**re: Landscaping Plan Review
Proposed Rezoning Lots 103, 104, 106, 119, 120, 122, 123, 124,
and 126
Proposed Residential Development – Kanata North – Brookline – Phase 1
936 March Road - Ottawa**

file: PG4554-MEMO.34 Revision 1

Landscaping Plan Review

FIGURE 1 - LANDSCAPING FOR LOTS SUBJECT TO REZONING

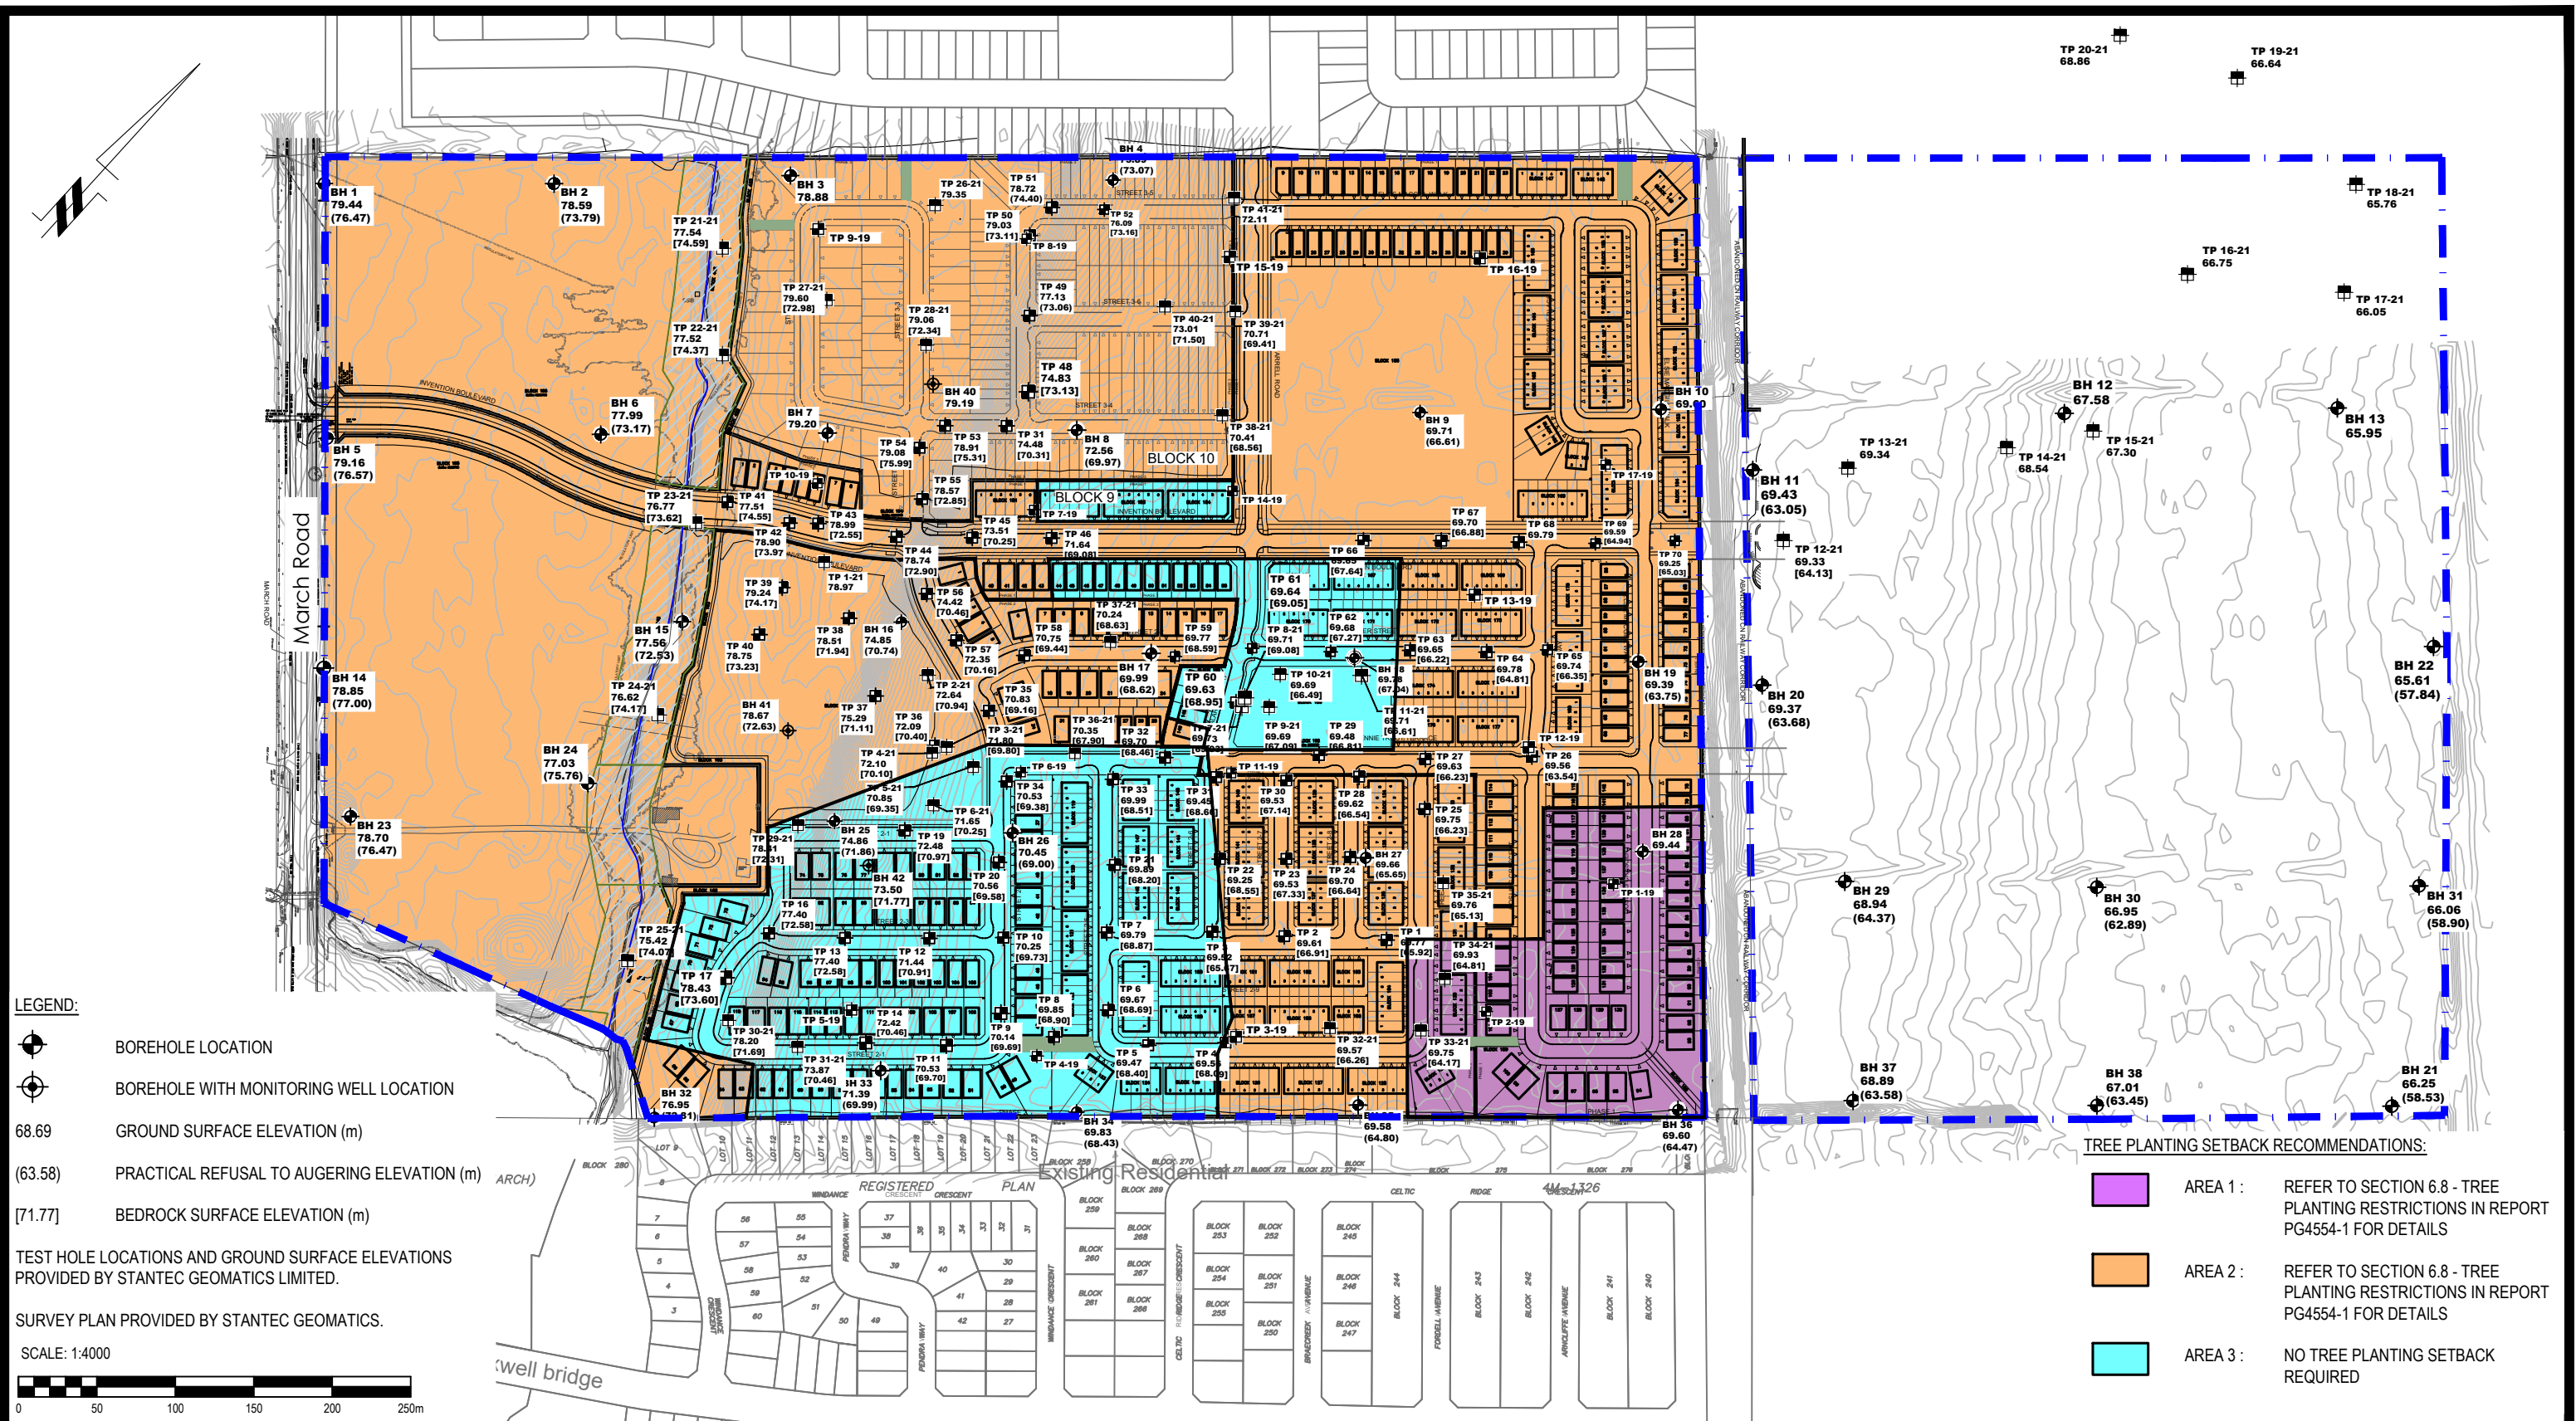
Based on discussions with Minto, it was understood that units 103, 104, 106, 119, 120, 122, 123, 124, and 126 are subject to rezoning, resulting a reduction in the width of the front yard setback from 4.7m to 4.2m. Paterson was requested to complete a review of the proposed tree planting setbacks for these units to confirm that they are in compliance with the tree planting setback recommendations provided in the above-mentioned geotechnical report.

Based on our review of the above noted drawings, it is noted that the above mentioned lots subject to rezoning will be located in Area 1- High Plasticity Silty Clay (Plasticity Index >40%). In accordance with the City of Ottawa Tree Planting in Sensitive Marine Clay Soils (2017 Guidelines), large tree can be planted in these areas with a minimum setback equal to the mature height of the tree. The tree planting setback limits may be reduced to 7.5 m for small (mature tree height up to 7.5m) and medium size trees (mature tree height 7.5 m to 14 m) in Area 1 provided that the following conditions are met.

Based on our review of the available drawings for landscaping for the lots subject to rezoning, it is understood that medium-size trees will be located along Gosling Crescent in front of the abovementioned lots. The minimum available setback between the proposed trees and the closest edge of the foundation wall for these units was measured to be 7.5m. Therefore, the proposed landscaping for Lots # 103, 104, 106, 119, 120, 122, 123, 124, and 126, following rezoning is in compliance with the City of Ottawa Tree Planting Setbacks for Trees within Sensitive Marine Clay Deposits, and are considered acceptable from a geotechnical perspective.

- The underside of footing (USF) is 2.1 m or greater below the lowest finished grade must be satisfied for footings within 10 m from the tree, as measured from the centre of the tree trunk and verified by means of the Grading Plan as indicated procedural changes below.

- A small tree must be provided with a minimum of 25 m³ of available soil volume while a medium tree must be provided with a minimum of 30 m³ of available soil volume, as determined by the Landscape Architect. The developer is to ensure that the soil is generally un-compacted when backfilling in street tree planting locations.

- The tree species must be small (mature tree height up to 7.5 m) to medium size (mature tree height 7.5 m to 14 m) as confirmed by the Landscape Architect.

- The foundation walls for the front side of the house and the front 2 m of the side walls of the house are to be reinforced at least nominally (minimum of two upper and two lower 15mm bars in the foundation wall).

- Grading surrounding the tree must promote drainage to the tree root zone (in such a manner as not to be detrimental to the tree), as noted on the subdivision Grading Plan
